Invitation to Tender (ITT)
Main Entrance/Colonnade Glazing/Roof Replacement
Reference #: NGC110697
Buy and Sell Reference #: PW-17-00789081
September 13, 2017

ADDENDA # 2

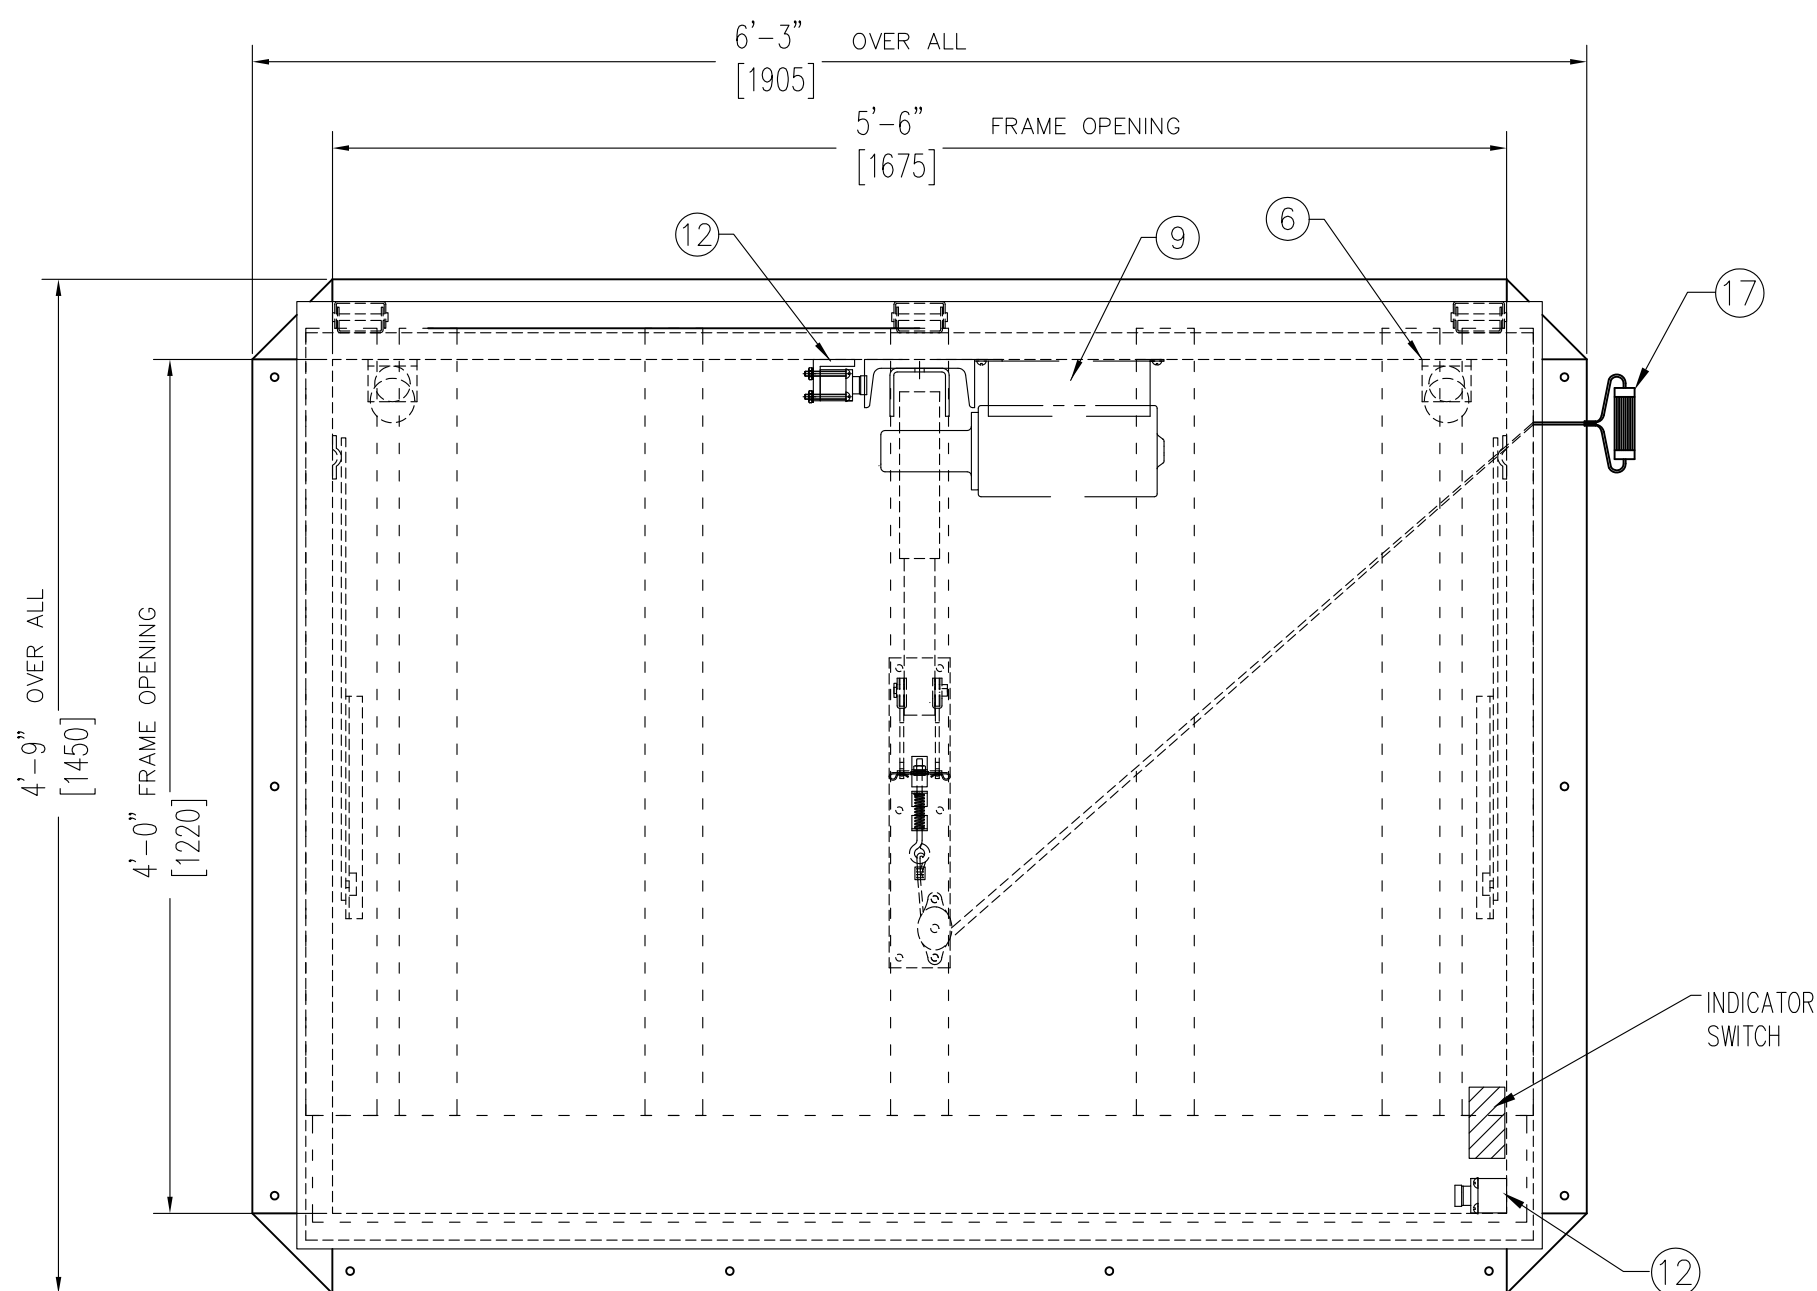
- a. This is for information only, is not part of the tender.
5. Appendix O - Section 3.3, 3.7 & Appendix Q - Items 27,28,29,30 & 31 on the Drawing Notes & Typical Drawings - Please provide a clear and concise specification for the metal/steel components of the roof structure. Please also provide a full cross section of the roof showing the intent of these members and the intended fixing details to existing members.

- a. The intent of the new roof construction is to provide a ventilated space beneath the lead coated copper roofing. The metal components are as described in Section 07 65 00 of the specifications:

- i. Item 27: As per Section 2.1.13 – joist modified to include 10mm vent holes at 50mm o/c. Dimensions scalable from the drawings.

- ii. Item 28: As per Section 2.1.10. Dimensions scalable from the drawings.
- iii. Item 29: As per Section 2.1.13. Dimensions scalable from the drawings.
- iv. Item 30: As per Section 2.1.14
- v. Item 31: As per Section 2.1.10 custom bent as required. Dimensions scalable from the drawings.
- vi. Fastening as described in Section 3. Lower framing to be fastened into existing corrugated metal deck.
- vii. A full cross section of the roof is not available. The detail through the upper portion of the roof is similar to the lower portion of the roof indicated in detail B6.29. The photos below show a representation of similar roofs with; 1) existing roof with exterior elements removed and 2) completed roof reconstruction.

SINGLE LEAF ROOF ACCESS HATCH SIZE 4'-0" x 5'-6" [1220mm x 1675mm]			
DRAWN BY	DATE	DRAWING NO.	REV.
	SCALE DO NOT SCALE

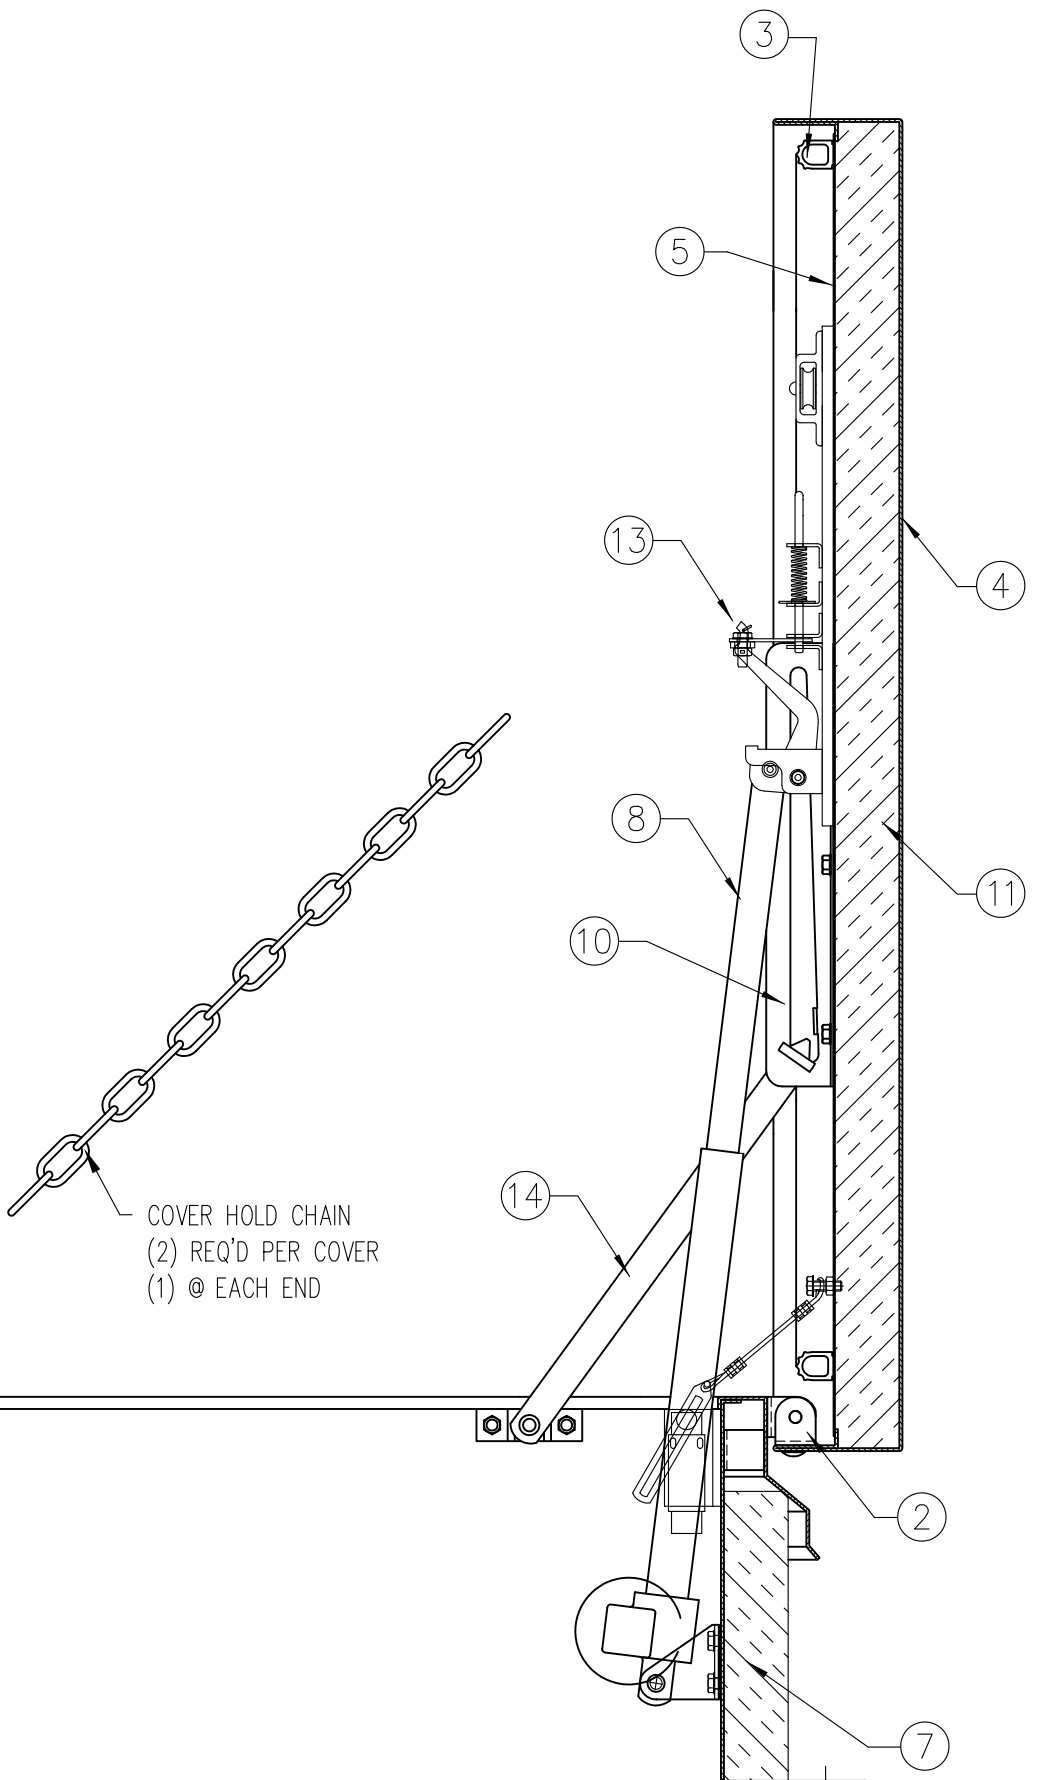
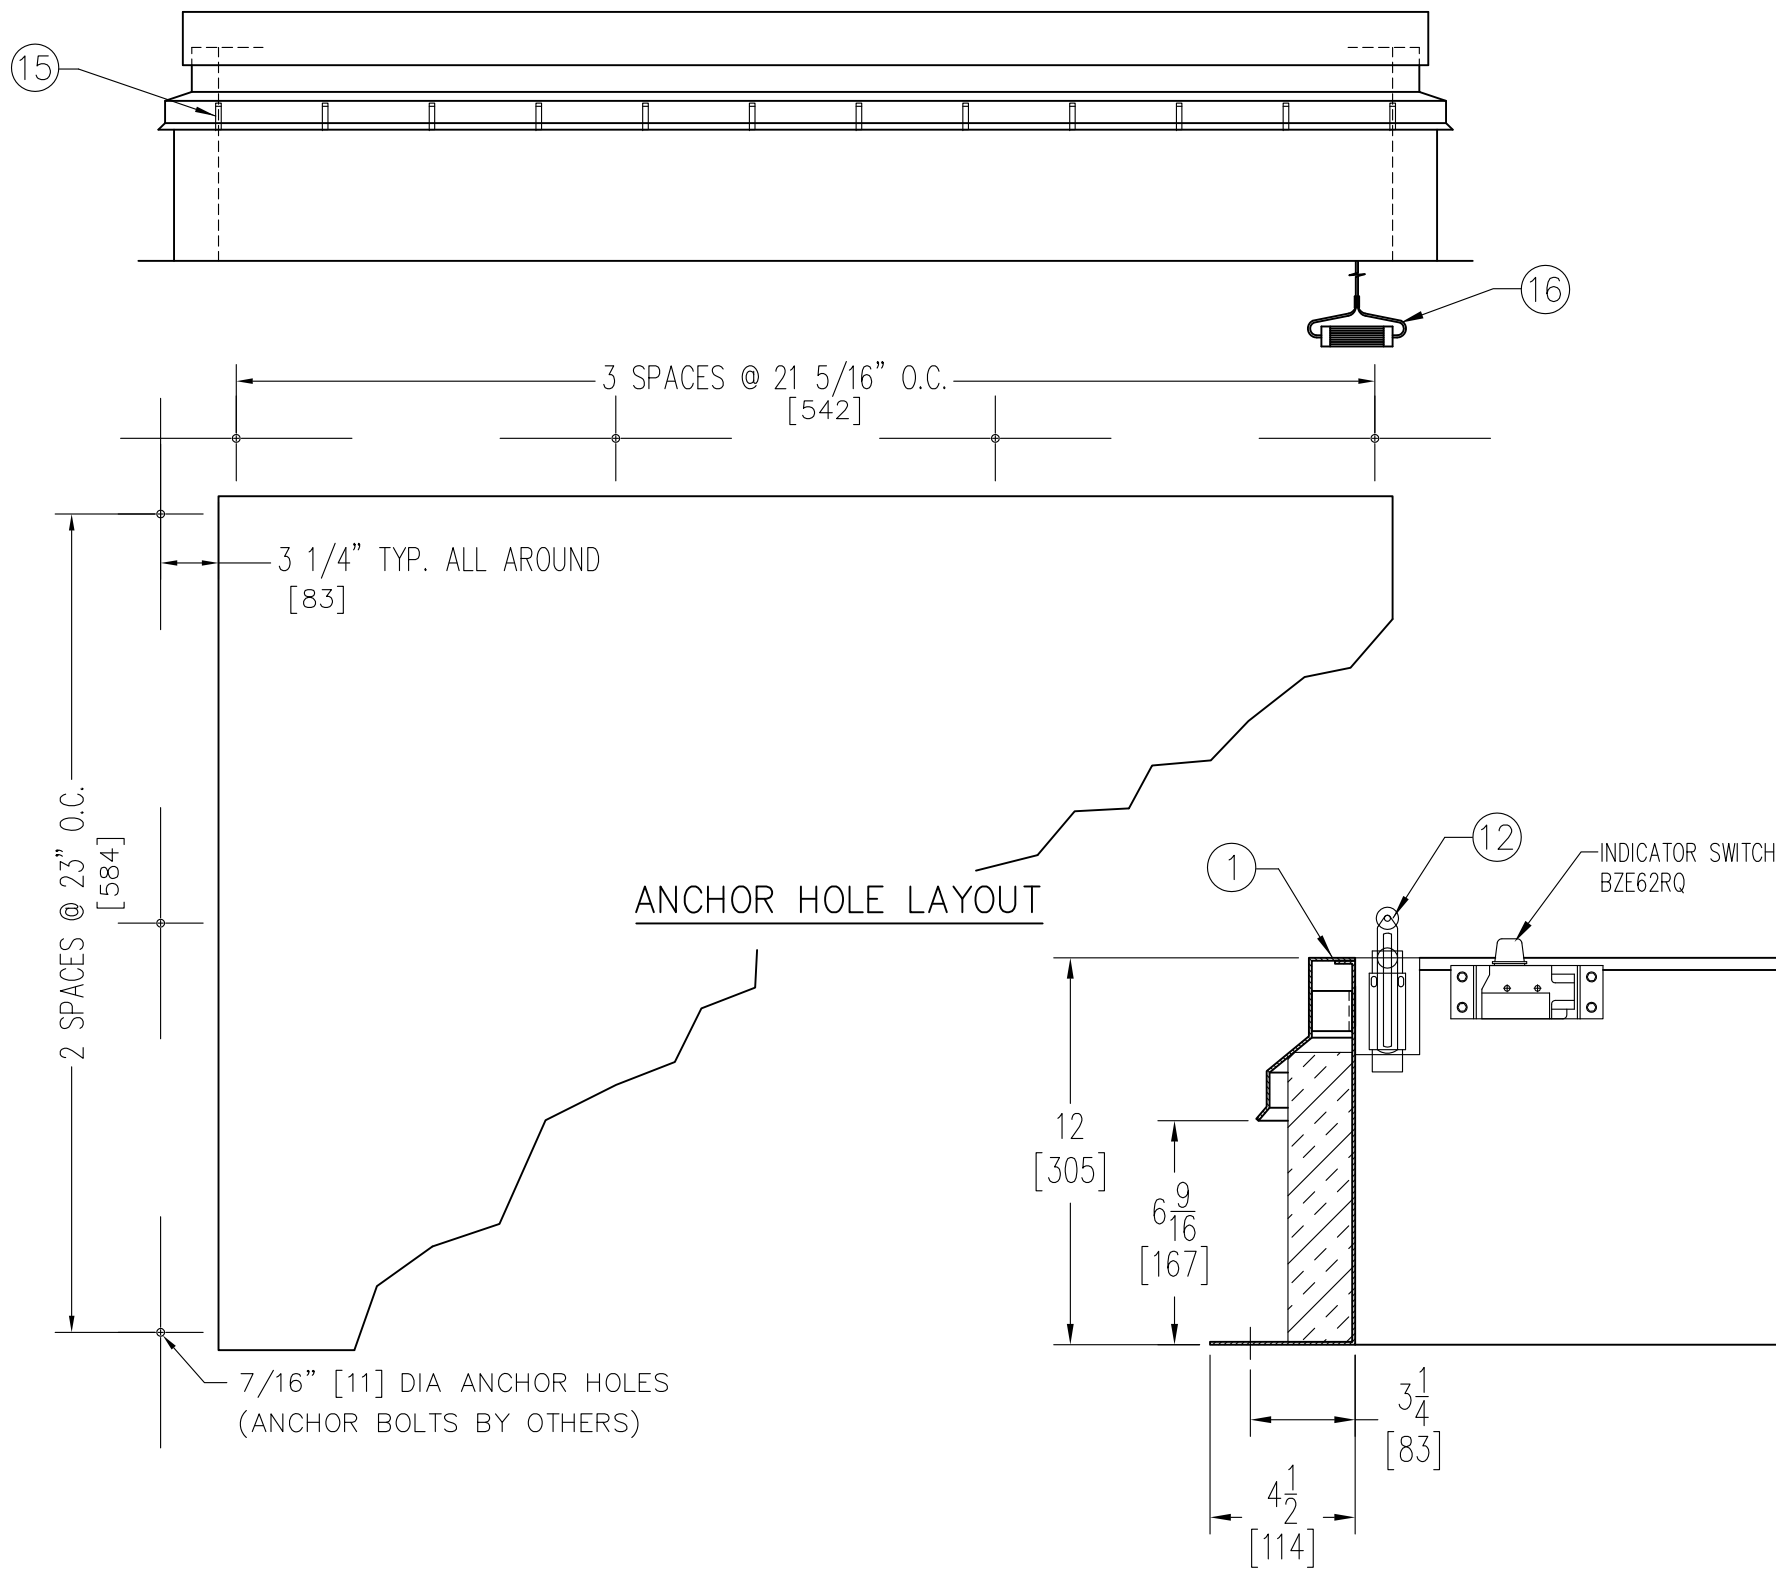
6. Appendix O - 07 65 00 3.6 - Please provide a specification and size for the new proposed Roof Hatch.
 - a. Please see attached sample data sheet, on page 5, for roof hatch.
